Mobile Intel[®] Pentium[®] II Processor Specification Update

Release Date: November 2001

Order Number: 243887-035

Old Mobile Pentium® II Processor in Mini-Cartridge Package Label with Supplier Matrix Mark

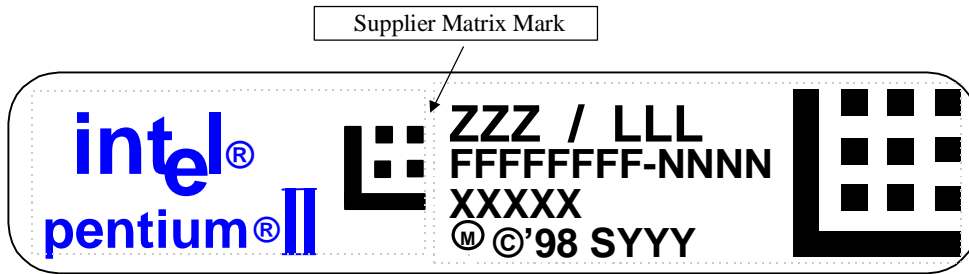
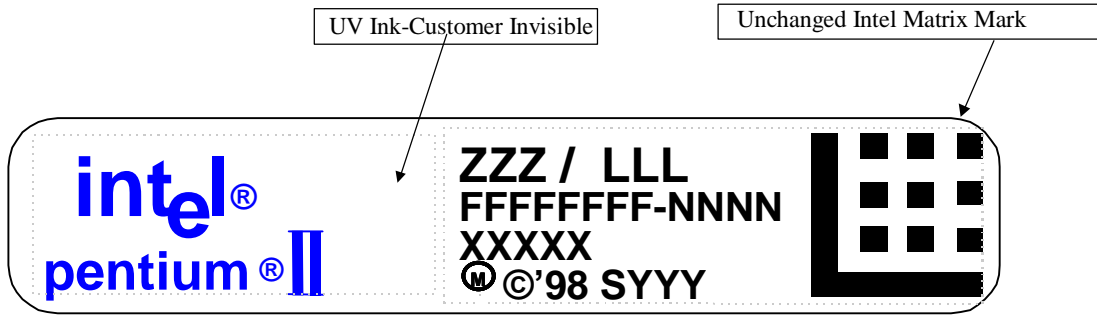
New Mobile Pentium® II Processor in Mini-Cartridge Package Label with Supplier Matrix Mark Removed

Figure 2. Workaround Flowchart: SMBALERT#-Driven System

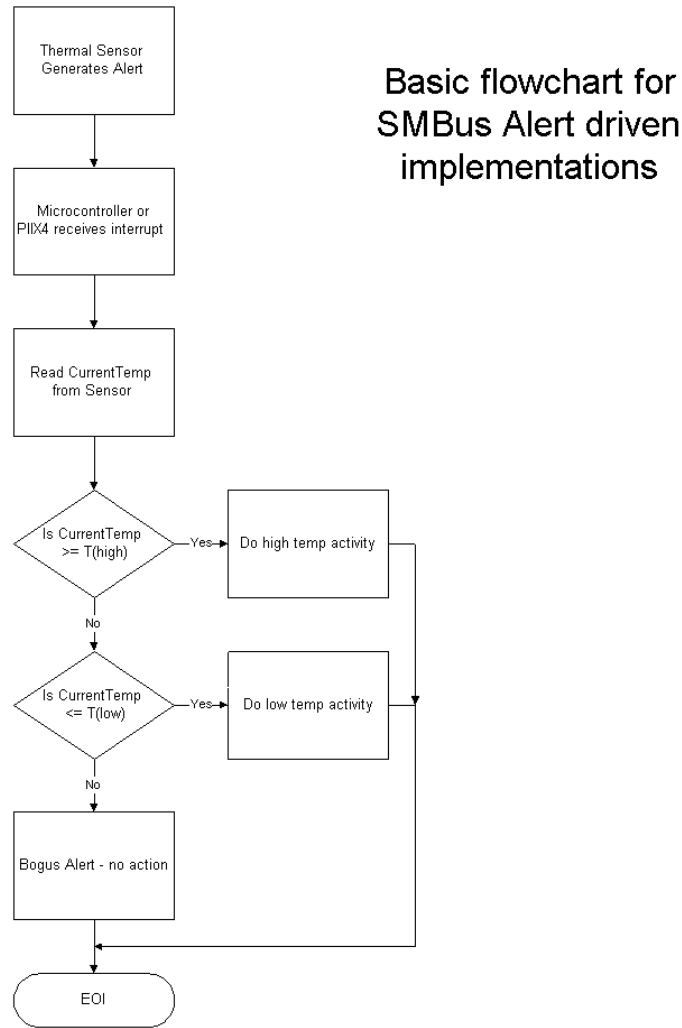
Under the conditions described below, the thermal sensor incorrectly generates the SMBALERT# interrupt. *All* of the following conditions must be met to trigger a false interrupt:

1. Before servicing an interrupt from the thermal sensor, read and compare the processor thermal reading with the threshold limits (T_{HIGH} or T_{LOW}). Figures 2 and 3 provide basic flowcharts for the implementation of this workaround in an interrupt driven system.
2. If the firmware implemented polls the Status Register only, then before taking any action, re-read the temperature register and do a comparison with the alarm threshold limits (T_{HIGH} or T_{LOW}) to determine if the value is actually still within the temperature window.

Figure 1. TAP Gageable Thread Clarification

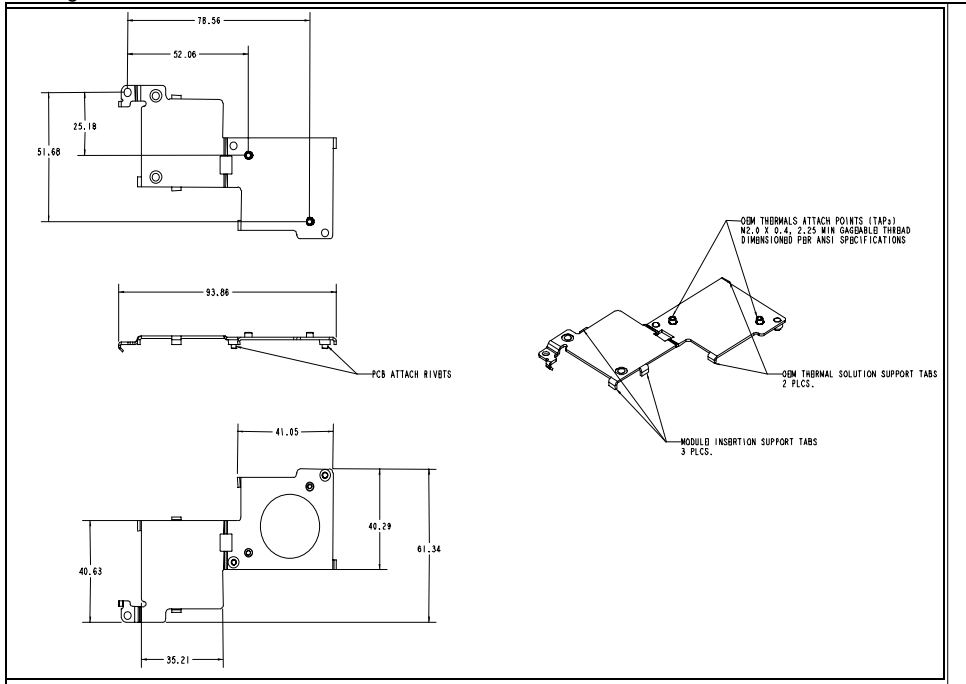
In the *Intel® Pentium® II Processor Mobile Module : Mobile Module Connector 1 (MMC-1)* and the *Intel® Pentium® II Processor Mobile Module : Mobile Module Connector 2 (MMC-2)* datasheets (Order Numbers 243667 and 243668, respectively), the thermal attach point (TAP) gageable thread specification was not clearly identified in Figure 14, of Section 5.2. The following is the TAP clarification:

OEM Thermal Attach Points (TAPs) M2.0 x 0.4, 2.25 min gageable thread dimensioned per ANSI specification.
